Re: FortisBC Energy Inc. (FEI)

2022 Long Term Gas Resource Plan (LTGRP) – Project No. 1599324

Response to the British Columbia Utilities Commission (BCUC) Information Request (IR) No. 1

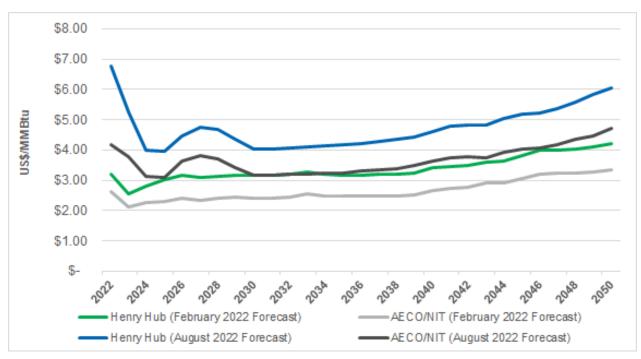
1	8.0 I	Referen	ice: F	PLANNING ENVIRONMENT		
2			E	Exhibit B-1, Appendix D-1 (Natural Gas Market Overview), p. 3		
3			L	∟ong Term Natural Gas Price Forecast		
4 5				o the Application provides a natural gas market overview. On page 3 of -EI states:		
6 7 8		f	orecast	01-2 below shows IHS Markit's (S&P Global) long term natural gas price , released in February 2022, for the Henry Hub and AECO/NIT markets in 1 dollars.		
9						
10 11 12 13 14 15		a r v e	and thus not illust vill be r endure	ally, this forecast was completed prior to the Russian invasion of Ukraine s does not include the impact of the current geopolitical climate and does rate the current futures price market. IHS Markit has since noted6 that they revising their outlooks to reflect "these new realities that we believe will over the next few years" which should be adjusted in their August 2022 m forecast.		
16 17	8			discuss whether IHS Markit has adjusted its long-term natural gas price to include the impact of the current geopolitical climate.

the impact of the current geopolitical climate. The updated figure below shows the latest longterm natural gas price forecast and the previous long-term natural gas price forecast for Henry

Although the adjustment to the IHS Markit price forecast shows a significant price increase for 2022, the prices drop back down to within the ranges shown in Figure B3-7 of the Application. Given the short-term nature of this price increase, the adjustment made by IHS Markit does not result in any material changes to the analysis presented in the Application.

1 Pathways Report Figure 10: Total GHG emissions in scenarios in the Pathways to 2050 report

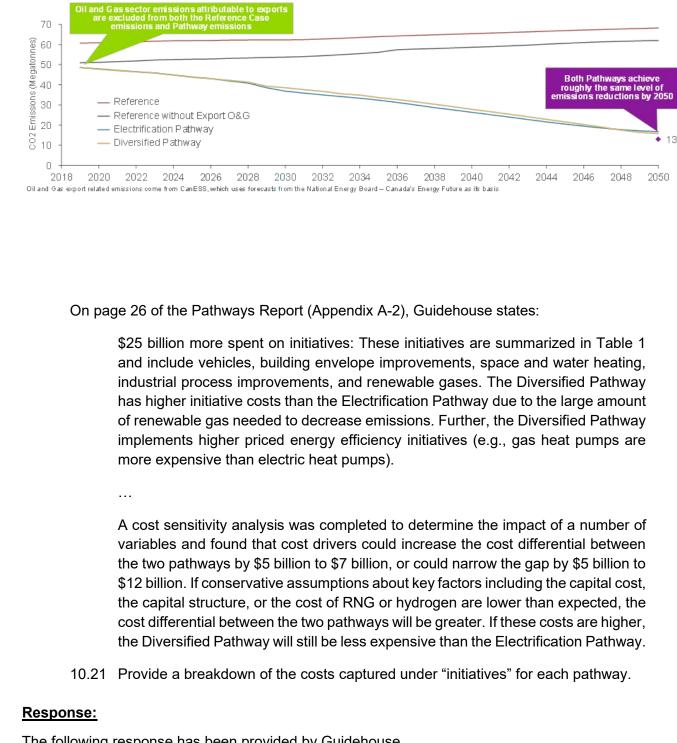
- 12
- 1310.20Please confirm that the sum of the GHG reductions illustrated in the electrification14pathway and diversified pathway in Figure 11 are not the same. BCUC staff15calculate approximately 27 MT and 33 MT respectively. Please explain the reason16for the differences.
- 17

- 19 The following response has been provided by FEI in consultation with Guidehouse.
- 20 Confirmed. The totals in Figure 11 should have been 32 Mt for the Electrification Pathway and
- 21 33 Mt for the Diversified Pathway. The reason for the difference is due to a categorization error
- 22 when Figure 11 was created.
- 23 The key point to be taken from Figure 11 is that both pathways achieve roughly the same emission
- reductions, as shown in the figure below from the Pathways Report in Appendix A-2 of the
- 25 Application (Figure 10).

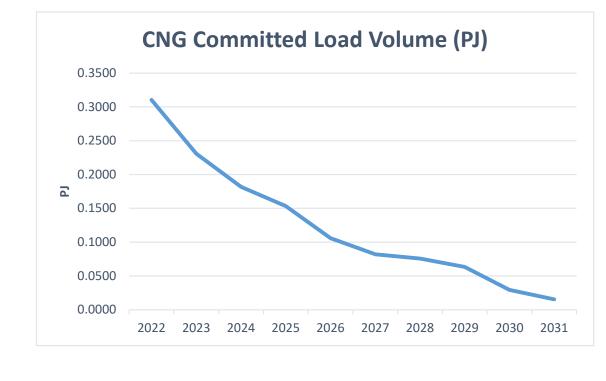
33.2 Please plot the demand expected solely based on commitments made by customers to take CNG supply from FEI on Figure 4-14, if possible.

be noted that the committed volumes show a decline over time as the graph represents current

volume commitments and those contracts have termination dates between now and 2031.

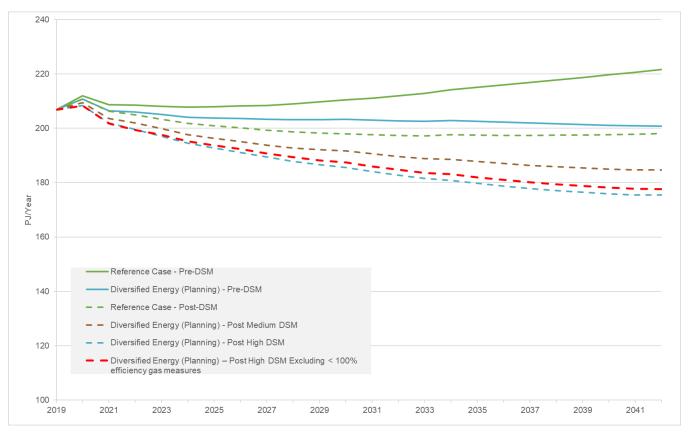
1		
2		
3	On pa	ge 2 in Figure C2-1 in Appendix C-2 to the Application shows the annual demand
4	before	and after estimated DSM Savings (Excluding LCT) – All Sectors Combined
5 6 7	36.5	Please provide an updated version of Figure C2-1, the results of an analysis showing the DSM market potential under the DEP High Scenario, if space and water heating equipment with efficiency less than 100% is excluded.
8		
9	<u>Response:</u>

11 Figure 1 below provides an updated version of Figure C2-1,⁴⁷ adding a line for the DSM market
